Proposed Amendments to the Jersey Avenue Park Redevelopment Plan Emerson District

November 3, 2016

Jersey Avenue Park Redevelopment Plan Circulation, Bikeways, and Open Space Map

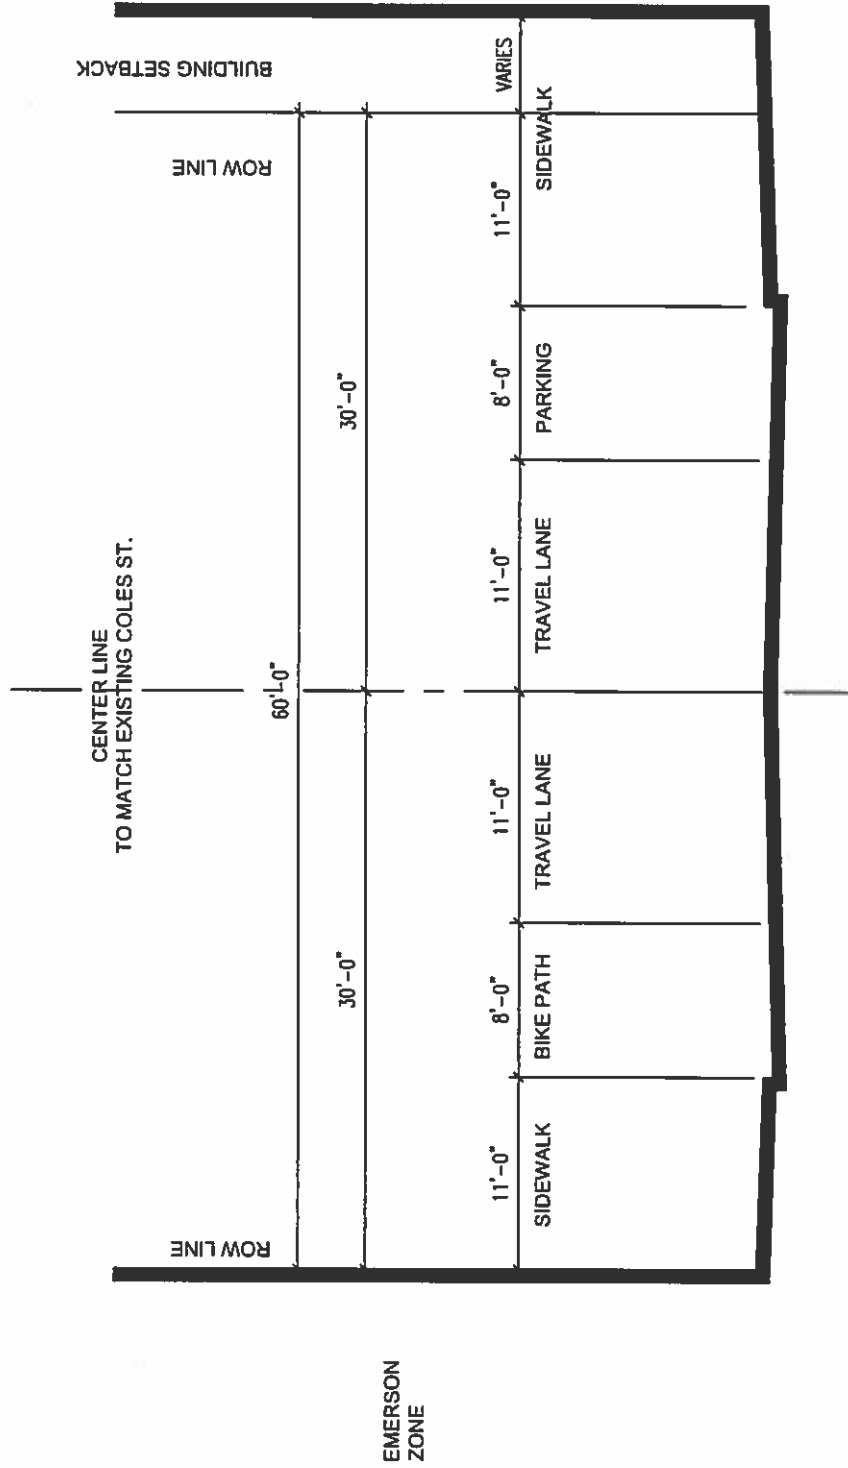
11. The construction of bikeways and public open spaces including the Coles Street Park and Emerson Park and as depicted on the Circulation, Bikeways and Open Space Map included within this Redevelopment Plan. Open spaces within the area shall be designed to introduce a range of functional and recreational elements to the District. Pedestrian walkways and bikeways shall be designed to link open spaces, residential, transit, office and retail elements within this and adjoining neighborhoods. Open space shall contain designed landscaping and lawns, high architectural materials and finishes for fencing, decorative walls, pedestrian pathways, seating, lighting and other hardscape furnishings. When designing open spaces access entry points shall take into consideration the location of ground floor uses at neighboring structures.

- 11. Open Space Contribution Requirements –** *The Developer upon approval of the first phase or building of any development shall contribute the sum of \$750,000.00 as an open space contribution. The Contributions shall be dedicated to the Jersey Avenue Park Open Space Fund. Contributions shall be payable as follows: 1/2 upon issuance of the first building permit for the first phase or building; and 1/2 upon issuance of the first of any certificate of occupancy for that specific phase or building. Use of the funds shall be put toward designated public open space as identified on the Circulation, Bike Pathways and Open Space Map of this plan.*

COLES STREET TYPICAL ROADWAY SECTION
 FACING NORTH

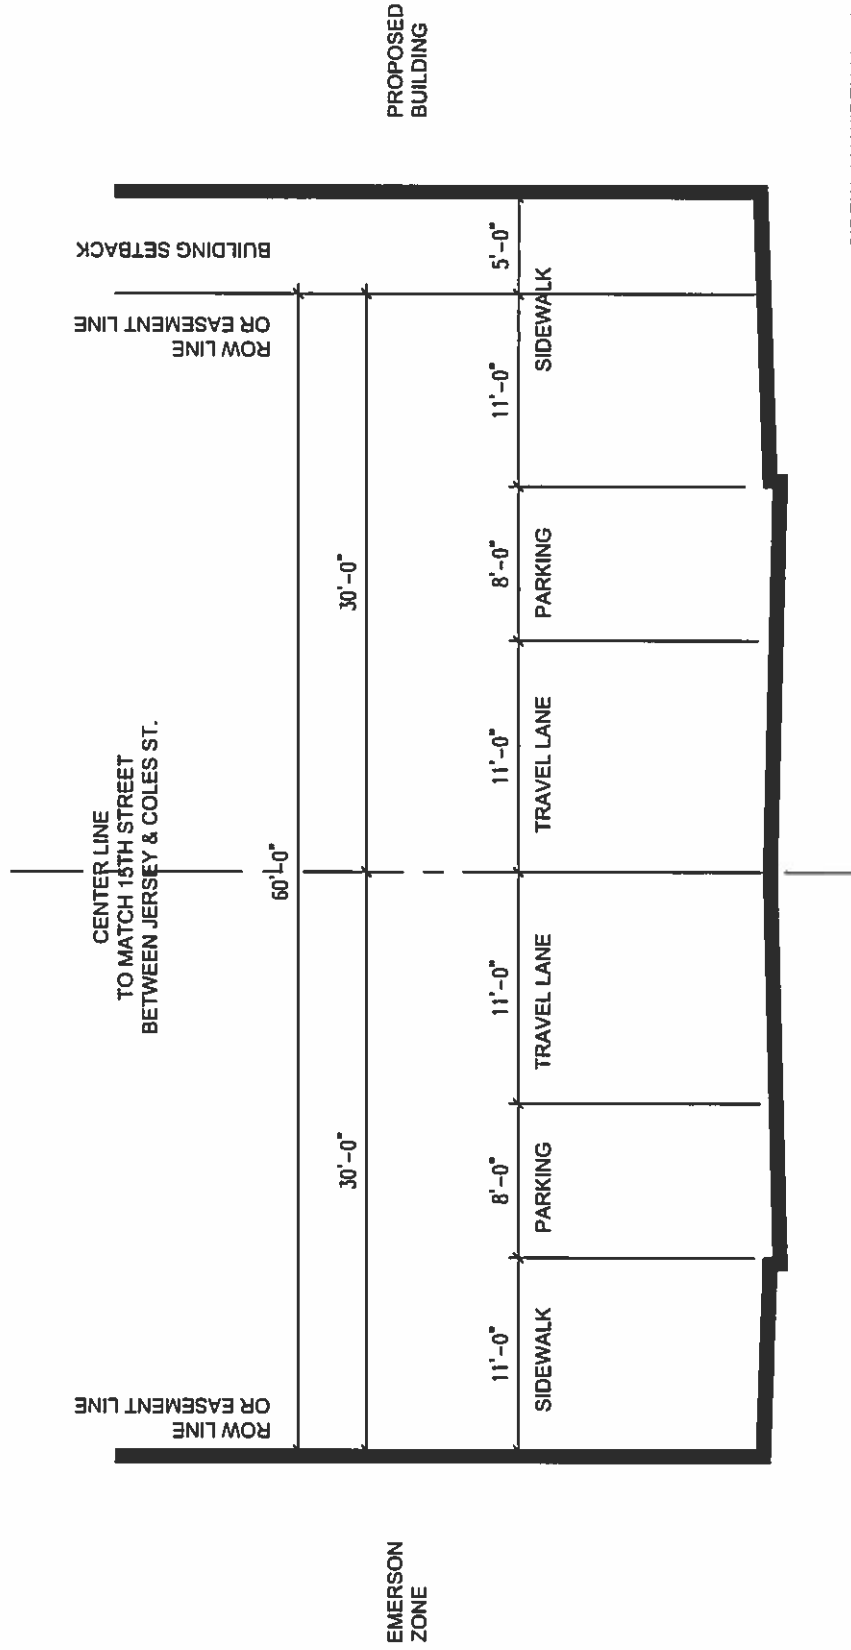
M. Fifteenth Street will be re-opened between Coles Street and Monmouth Street as part of the redevelopment of the Emerson District. Typical Cross Sections for Fifteenth Street and Coles Street are included within this Redevelopment Plan.

**15TH STREET TYPICAL ROADWAY SECTION
BETWEEN COLES STREET & MONMOUTH STREET
FACING EAST**

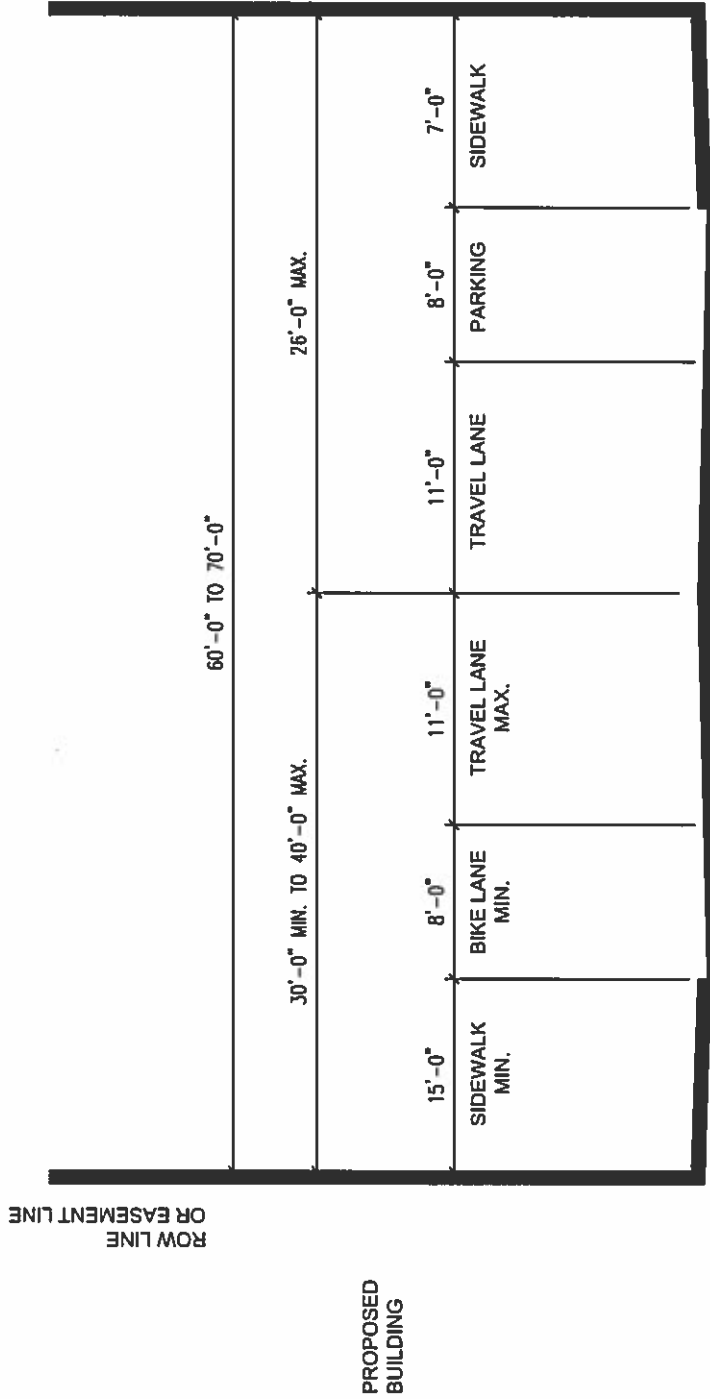
J. *Open Monmouth Street to extend from Thirteenth Street to Hoboken Avenue with a right-of-way width of 60-70 feet. The City shall work with the property owners adjacent to Monmouth Street north of Thirteenth Street to accomplish the reopening of any portions of the roadway that were previously vacated. Typical Cross Sections for Monmouth Street are included within this Redevelopment Plan illustrating the full 60-70 foot wide right-of-way, which may be constructed as determined by the planning board.*
